Pearson-10M #61

SUBJECT: Lifeline Locknuts

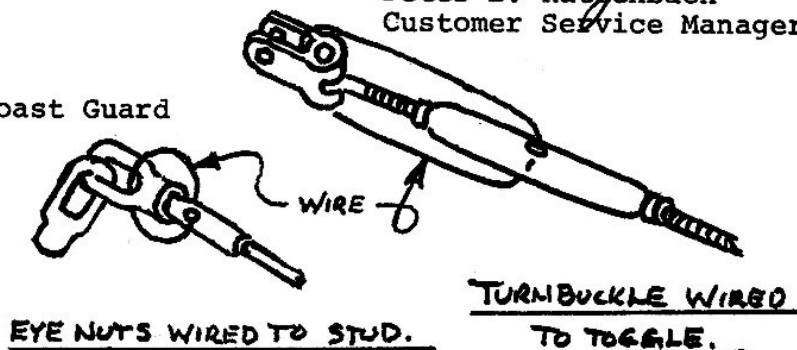
We've noticed that in some instances, it may be difficult to keep the locknuts tight enough on the lifeline turnbuckles to prevent the lifeline from becoming unthreaded. After studying the situation, it has been determined that if the turnbuckle barrels are wired to the adjacent toggles, and the eye nuts are wired to the hole in the threaded stud, the probability of the lifeline becoming unthreaded is virtually eliminated.

The following sketches will help you to understand the recommended steps. Enclosed herewith is four feet of 1 x 7 annealed stainless steel wire. It should be of sufficient quantity.
